ADDENDUM NO. 2

TO
CONTRACT DOCUMENTS AND TECHNICAL SPECIFICATIONS
FOR THE
WATER TREATMENT PLANT DISINFECTION IMPROVEMENTS
IN
ANTIOCH, CALIFORNIA
P.W. 246-29

ISSUED
March 16, 2017

CITY OF ANTIOCH
WATER TREATMENT PLANT DISINFECTION IMPROVEMENTS (P.W. 246-29)

PROJECT NO. P.W. 246-29
 FIGURE NAME 01_Addendum-2.dwg
 SHEET NO.
C-1

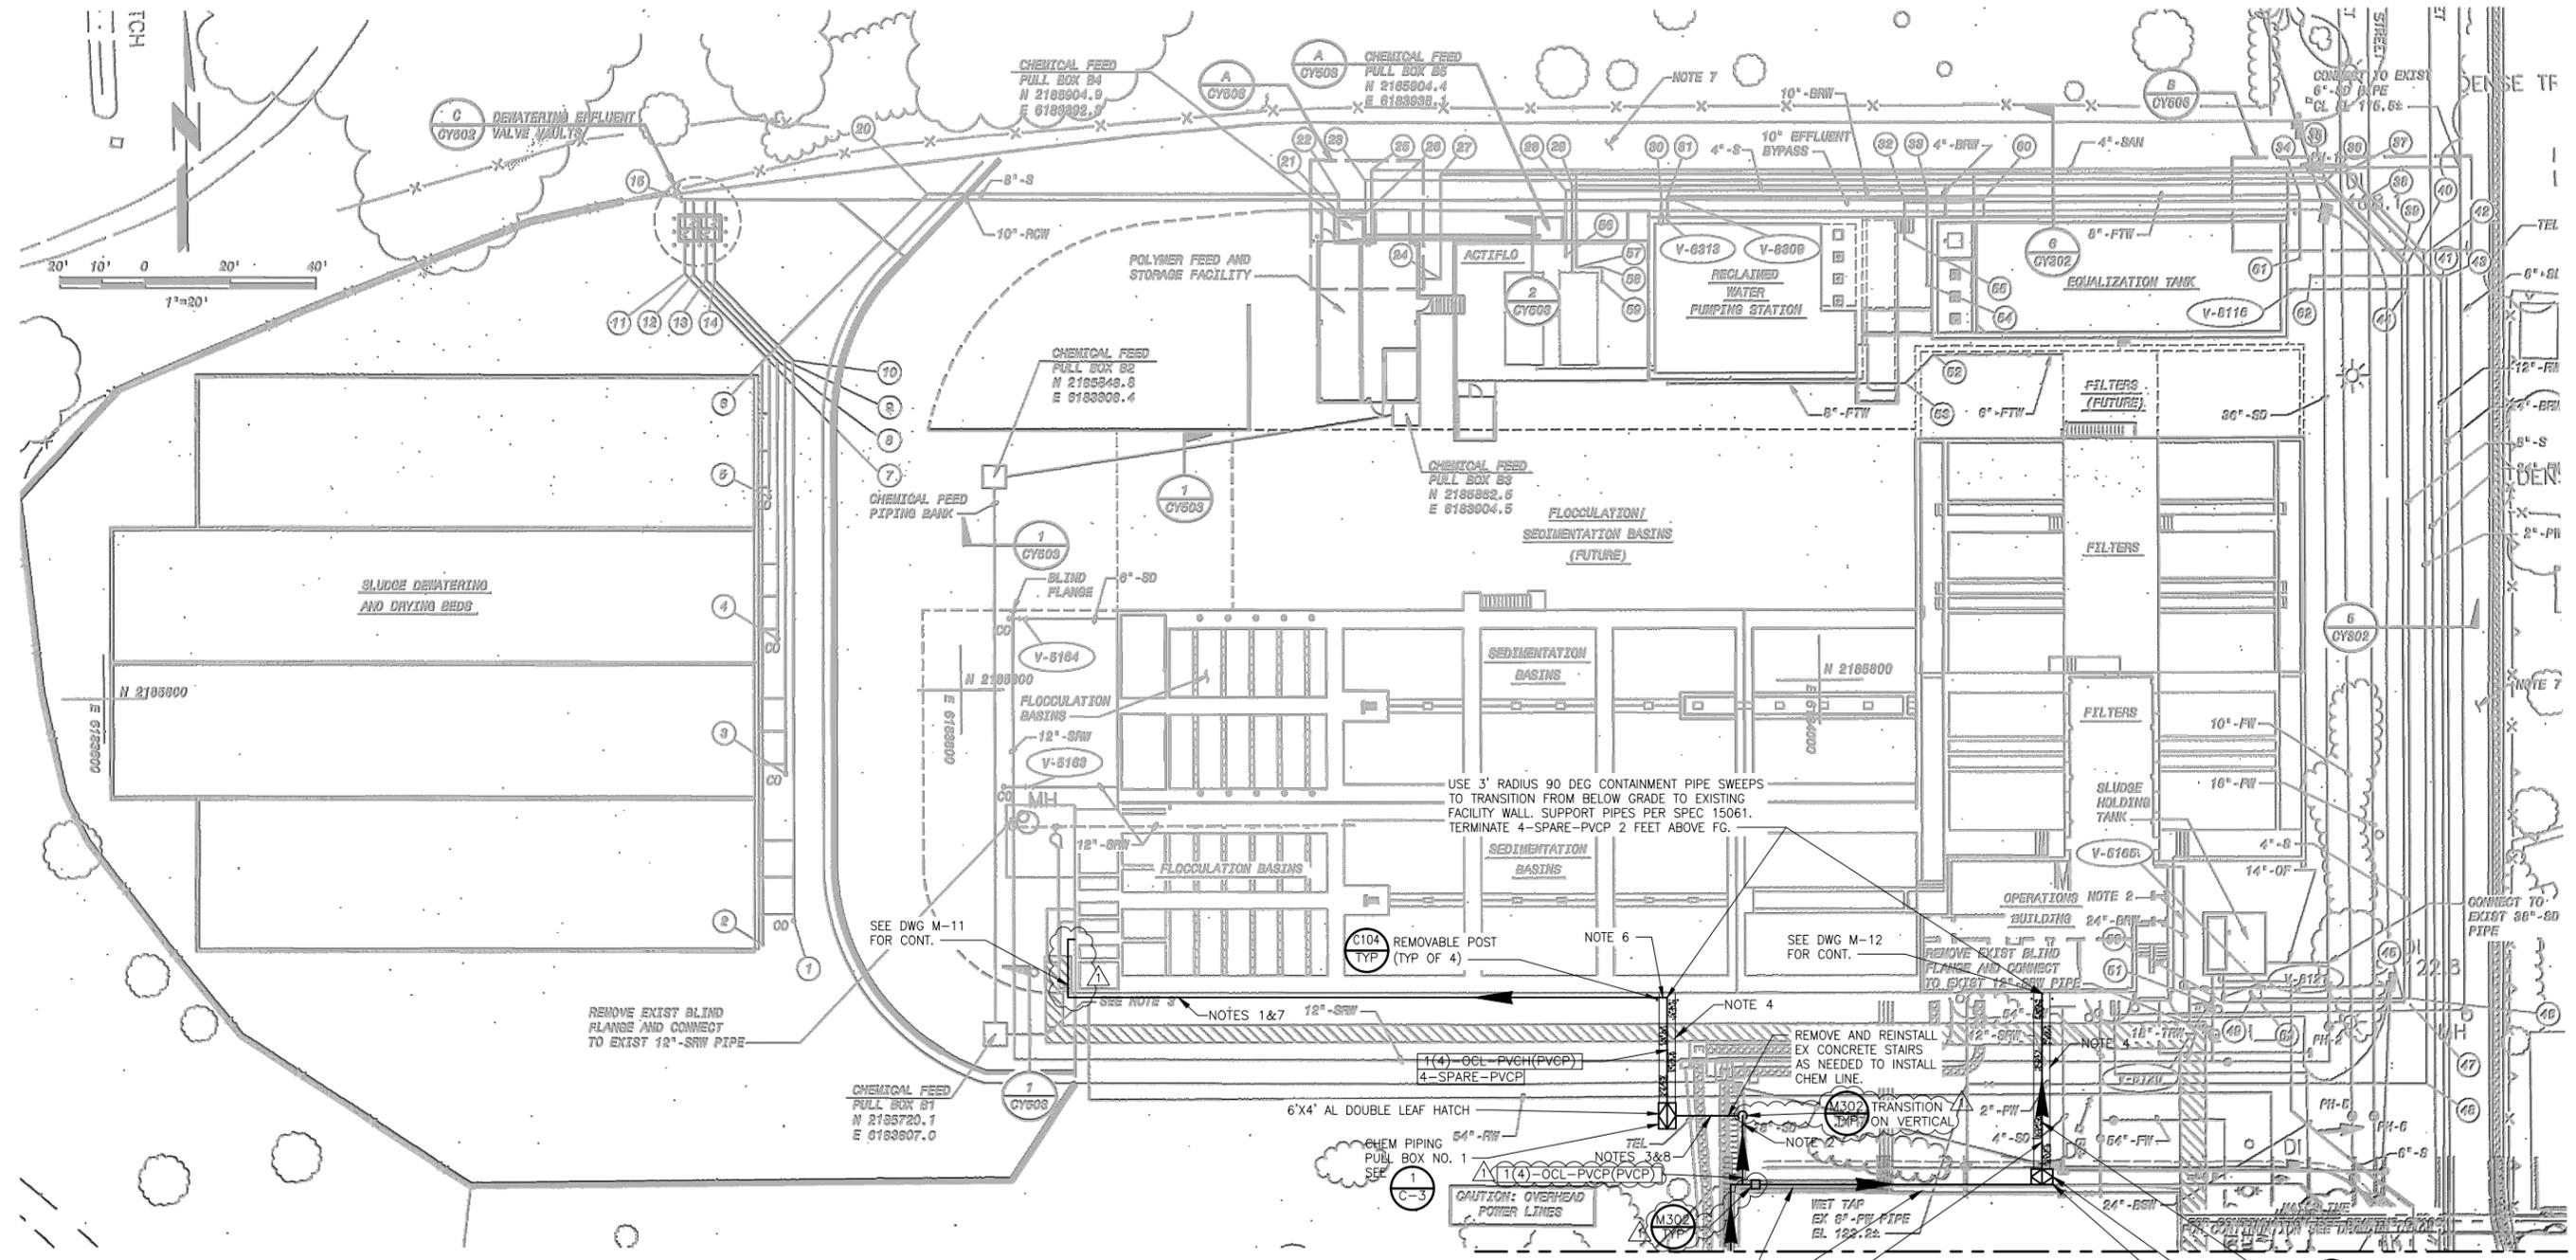
- 2. Drawings C-1 and C-2 show all chemical lines to be PVC hose inside a PVC containment pipe, except for the 2" pipe that goes from the hypochlorite tanks to the metering pumps. On drawings M-5, M-9, M-10, M-11 the OCL carrier pipes are shown as PVC pipe, not hose. Please clarify.***

Response: See modification to Drawings for Sheets C-1, C-2, M-3, M-5, M-9, M-11, and M-12 for clarification.

Delete sheet in its entirety and replace with the attached Sheet C-1.

TYPICAL CHEMICAL HOSE
 CONTAINMENT TERMINATION
DETAIL M206
 NTS TYP

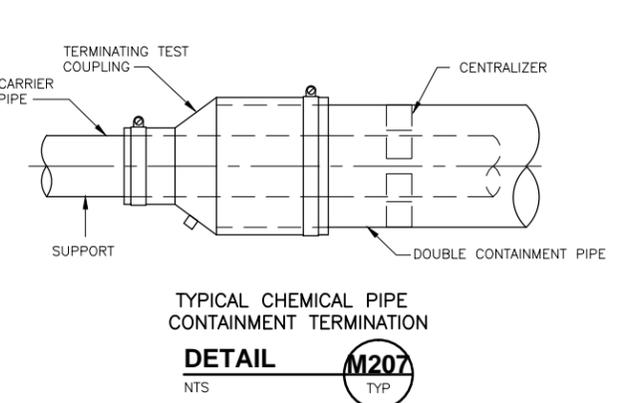
- 3. Detail M-206 on drawing MD-2 shows centralizers for supporting PVC hose. According to our PVC supplier, this application is not used and cannot be installed. Can the centralizers be eliminated for PVC hose?**

Response: Centralizers for PVC hose support are eliminated. See modification to Drawings below.

Delete sheet in its entirety and replace with the attached Sheet MD-2.
